Sunset Arts & Advertising Subcommittee Briefing Memo Current and Historic Preservation Planning

8760 Sunset Boulevard

Proposed Billboard Application: The purpose of this meeting is to give initial feedback on design aspects of the proposed billboard structure at this location. This includes one sided, full-motion animated billboard both facing west. This site currently has no billboards.

OPTION B: SONIC SYMPHONY

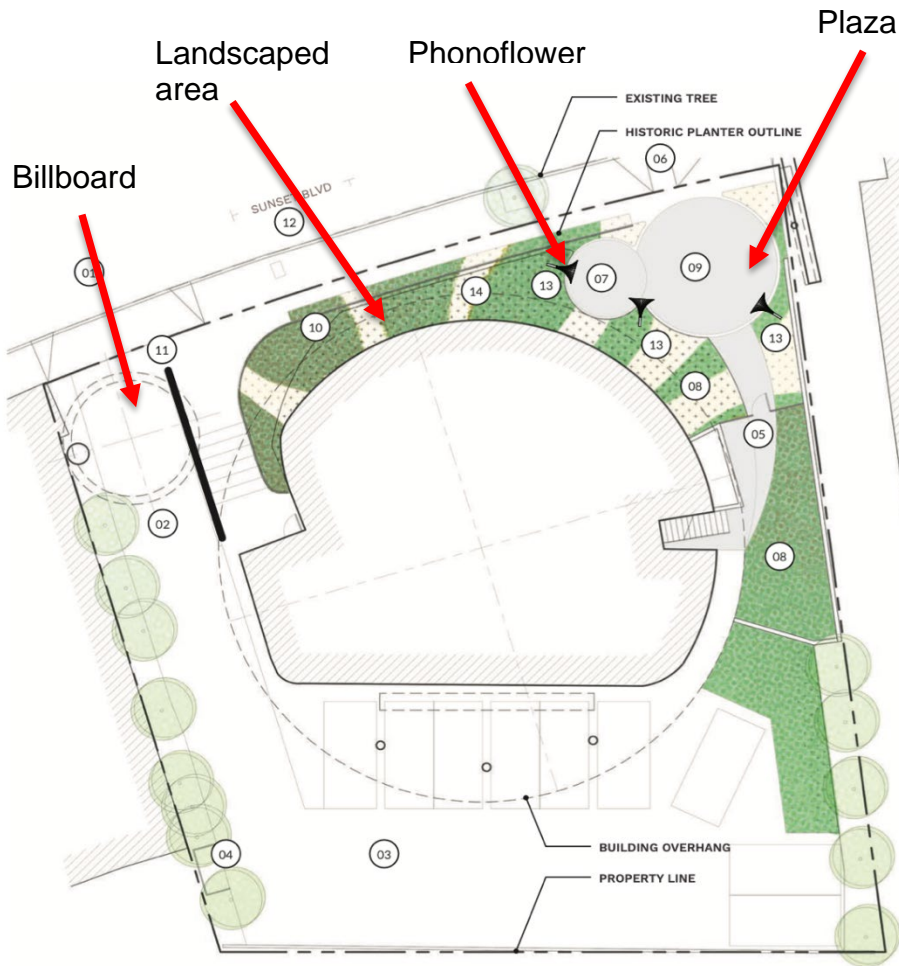
Regardless which option is recommended, it will be important to have some analog means (not merely a QR code) that tells the story of the relationship between the music and nature and how that translation will take place. Similar consideration should be given to the telling of the story of the “landscape as canvas” and the long-term maintenance of this area.

Proposed Site Plan

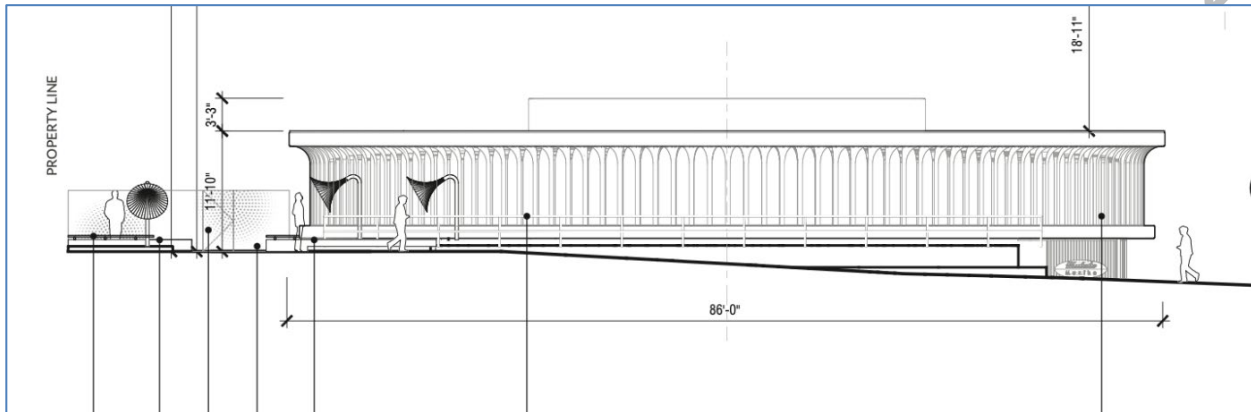
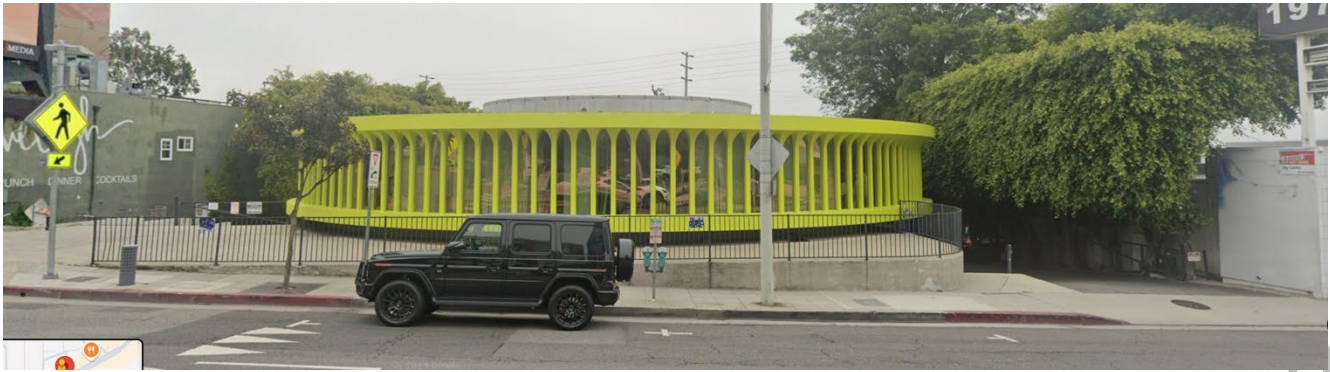
The plaza itself will contain bench seating and be finished with gray, 4" thick narrow modular pavers. The benches should be carefully designed to promote the types of activity desired. Contrasting the concrete sidewalk, the pavers will help distinguish the private plaza from the sidewalk. Alternating colors or paving or the introduction of creative patterns would further help mark the plaza as a unique place. Lighting of the plaza should be soft and subdued but account for nighttime safety considerations.
